# Access Compliance Report

## Public Rights-of-Way

### (Curb Ramps)

Intersection ID: 5600	Main Street: N_TRYON_ST	Cross Street: J_M_KEYNES_DR	Location: N
ADA ID: 787C50C617CF	Ramp Type: Perp	Initial Pass/Fail: Fail	Overall Compliance: No
Severity Score: 10			
Codes/Mitigation Info/Possible Solution		Field Measurements/Component Compliance

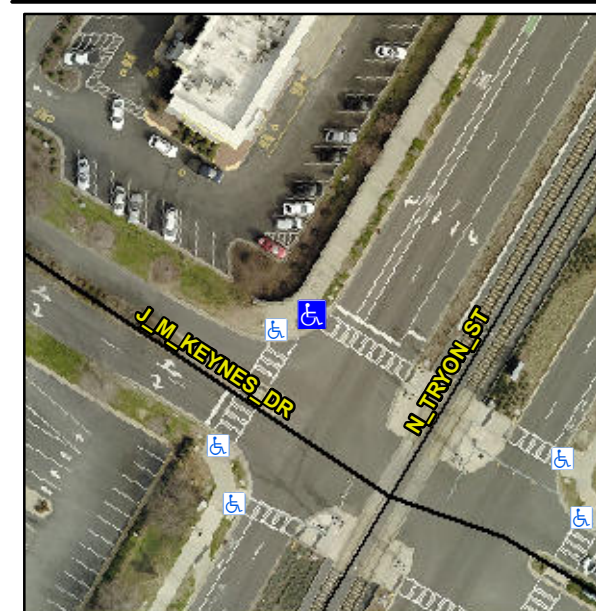
**Remove & Replace Entire Ramp.**

**R304.5.1, R304.5.3**
